**Comment Summary – January 13, 2025 (5<sup>th</sup> Submission)**  
**Zoning By-law Amendment Application – WDD Main St. Inc.**

RE: **NPG Comments  
Main St  
RE: Application for Zoning By-law Amendment & Draft Plan of Subdivision**

**Re: Zoning By-Law Amendment 5th Submission  
11 Main Street (Morrison)  
Puslinch, ON**

**RE:** Hydrogeological Review Comments - 5th Submission  
WDD Main Street Inc. - 11 Main Street, Morriston (Puslinch), Ontario  
Proposed Residential Subdivision  
Zoning By-law Amendment / Draft Plan of Subdivision Application

# Post-Development Uncontrolled Visual-Oththymo Schematic

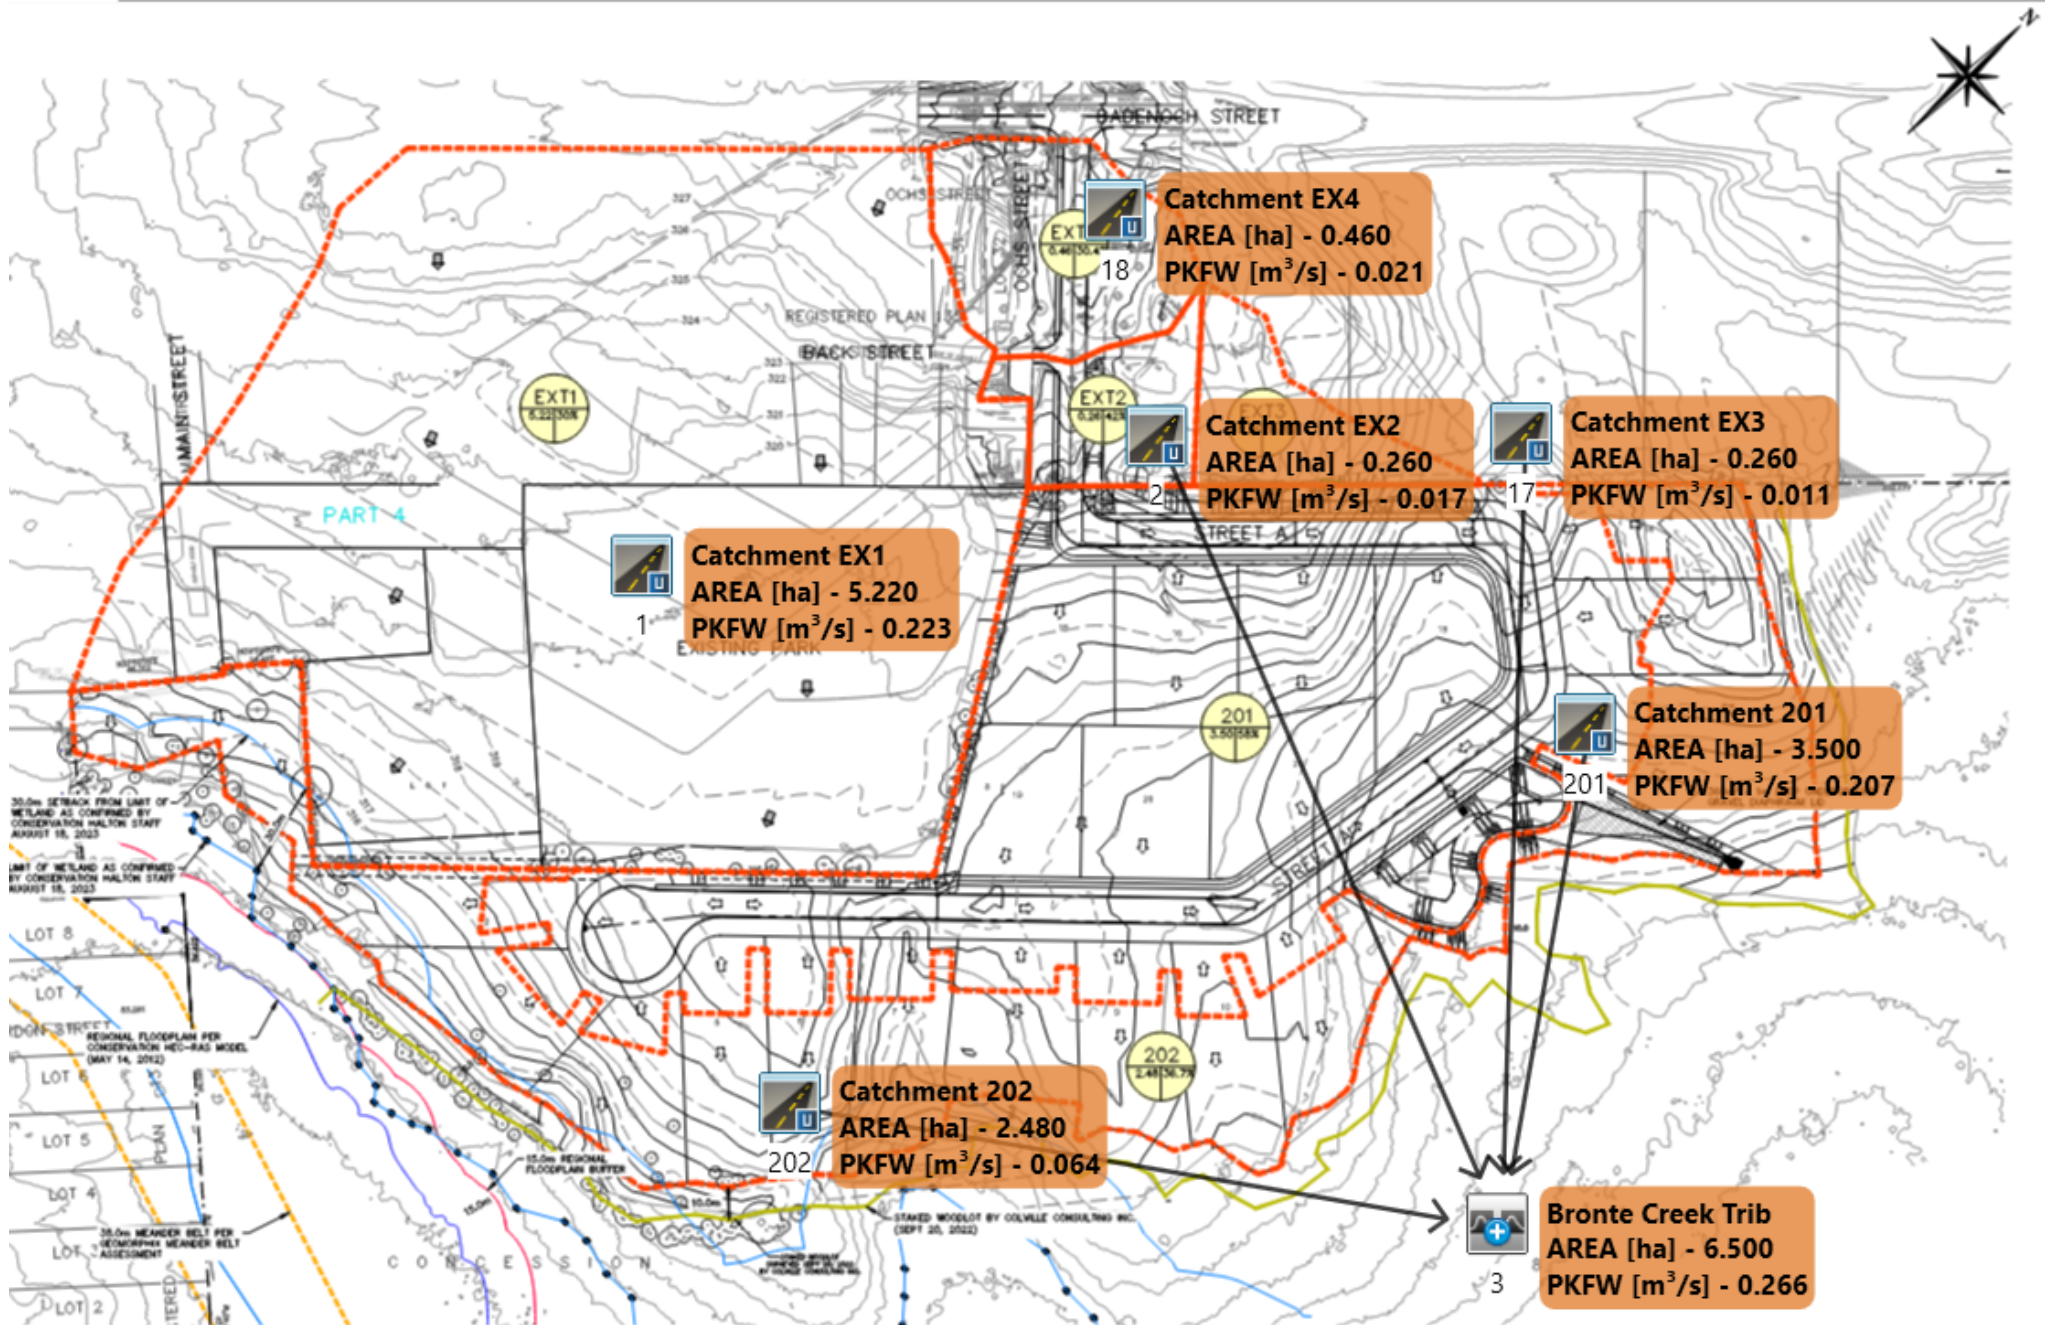
12.	Stormwater Model – Visual OTTHYMO	FSR – VO Schematics	April 20, 2023	<p><u>GEI Comment (April 20, 2023)</u>                  Please replace the wording of the “Post-Development” schematic title to reflect a post-development uncontrolled scenario.</p> <p>Please replace the wording of the “Post-Development w/ Mitigation” to be “Post Development Controlled”. This will make it consistent with Table 8 in the report and will make ultimate conditions clear.</p> <p><u>Crozier Response (January 2024)</u>                  The Visual OTTHYMO and schematics has been updated to reflected Table 8.</p> <p><u>GEI Comment (February 9, 2024)</u>                  Accepted, no further comment.</p>

2024/11/01 - Site Photo of general slope of  
Old Morrison Baseball Diamond (EX1) -  
Photo taken looking west

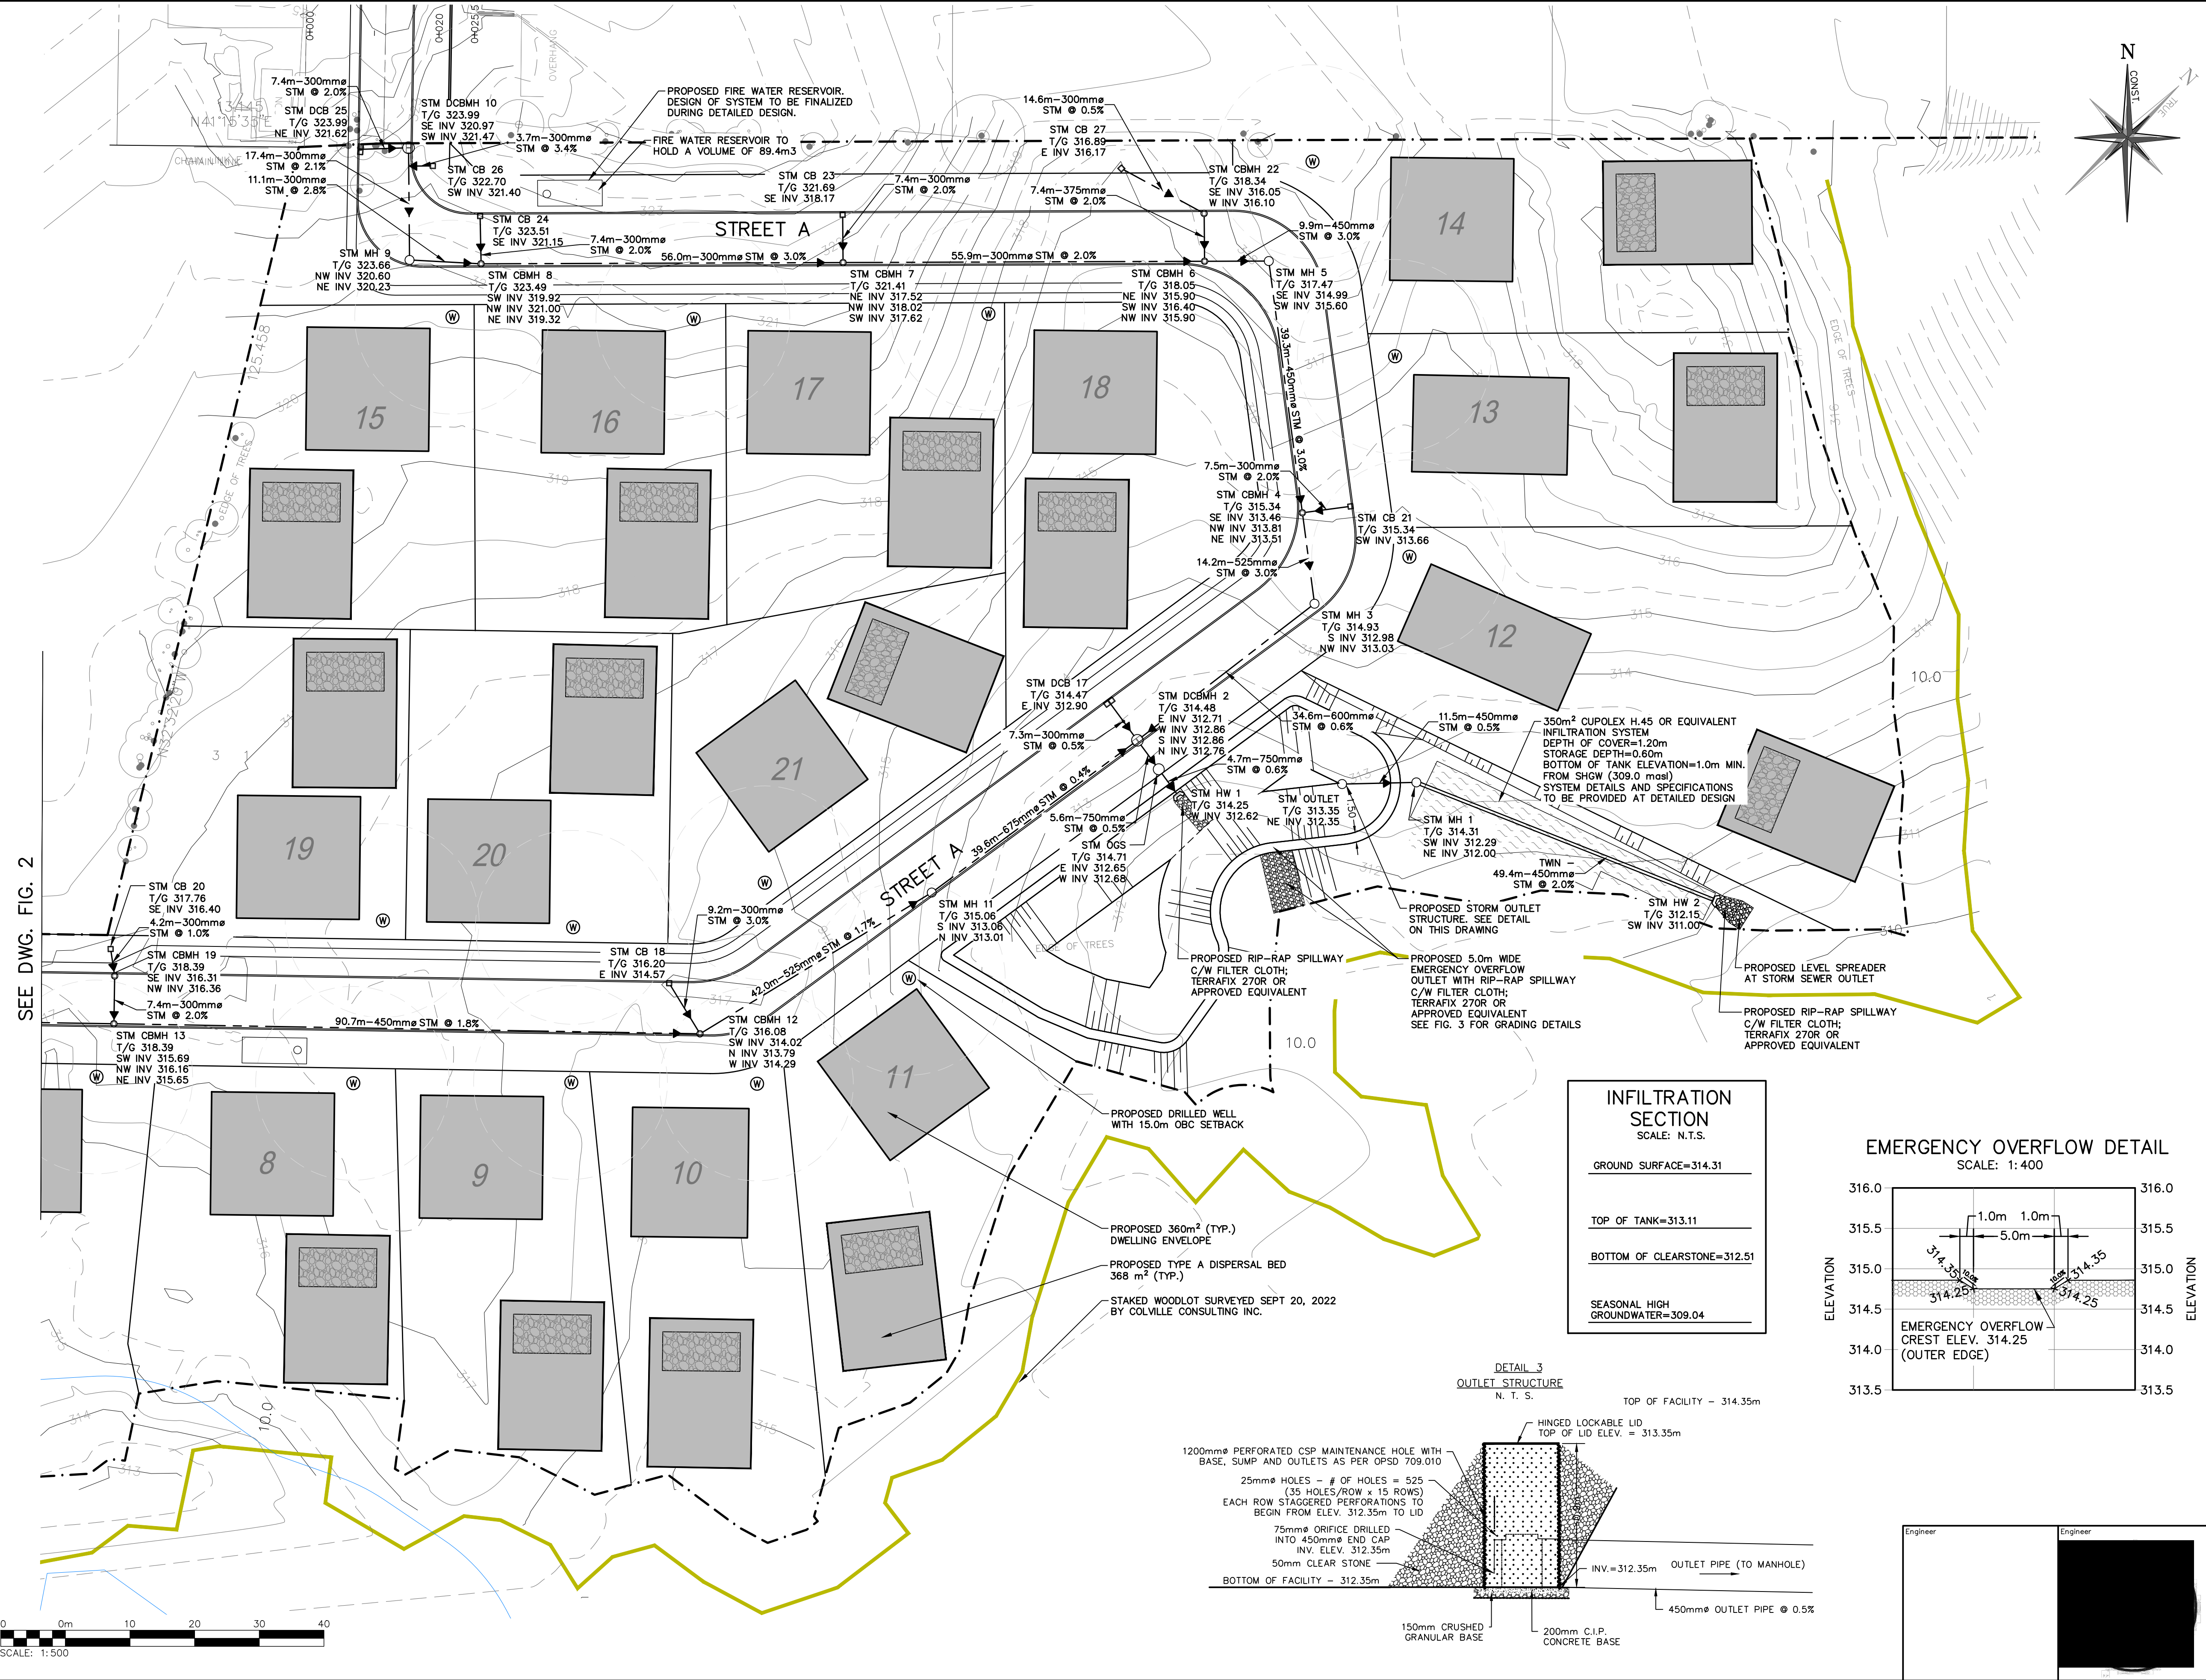
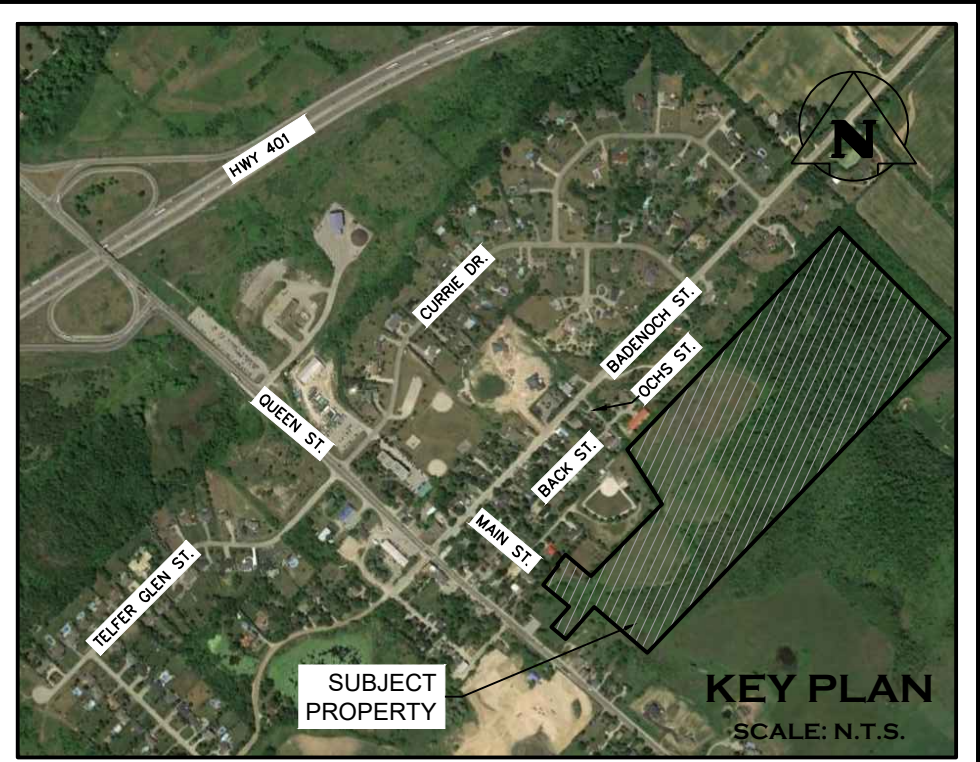
15.	External Area Topography	Engineering Plans	February 9, 2024	<p><u>GEI Comment (February 9, 2024)</u>                  The FSR states that, based on existing LiDAR contour mapping, runoff from external catchment EX1 ponds along</p>

<p>existing berms and then drains southwest towards Bronte Creek.</p> <p>Please show these existing contours and berms on the Engineering Plans to confirm that this flow route will be maintained. Additional topographic survey may be required on the adjacent lands.</p> <p><u>Crozier Response (September 2024)</u> The existing contour mapping (LiDAR) has been added to the engineering drawing set to show the external runoff drainage conditions.</p> <p><u>GEI Comment (September 2024)</u> The LiDAR mapping does not appear to show the berms. Please provide <b>topographic data</b> for the existing ball diamond area (EX1) to show the low-lying depression area where ponding reportedly currently occurs per the report, and the existing berms. Please demonstrate the conditions under which it can be expected that the existing storage limits will be exceeded, and stormwater will flow onto the subject lands. Please clearly show how these flows will be routed around the development, specifically lots 1 and 2, to the Bronte Creek outlet. Please demonstrate that flows from EX1 will not enter the proposed stormwater facility.</p> <p>As previously discussed, site visit photos may be helpful to show the extents of existing surface ponding in the park area under typical conditions.</p> <p><u>Crozier Response (November 2024)</u> Refer to FIG 4 a proposed a swale within the drainage easement to control flows from EX1 and route between Lots 1 and 2 has been added.</p> <p>We suggest that a topographic survey to be completed on the Morriston Ball Park during the detailed design phase and not as part of Draft Plan Approval. We also note that access to approval will be required by the Township prior to completion of any survey on adjacent lands. We have provided site photos of the park in Appendix H to demonstrate existing topography and drainage conditions.</p> <p><u>GEI Comment (December 13, 2024)</u> The topographic survey should be completed at detailed design and the Grading Plans updated accordingly to clearly identify top of berm, bottom of berm and ponding limits. The Township has already granted access approval to the Ball Diamond and any other Township lands for surveying purposes.</p>
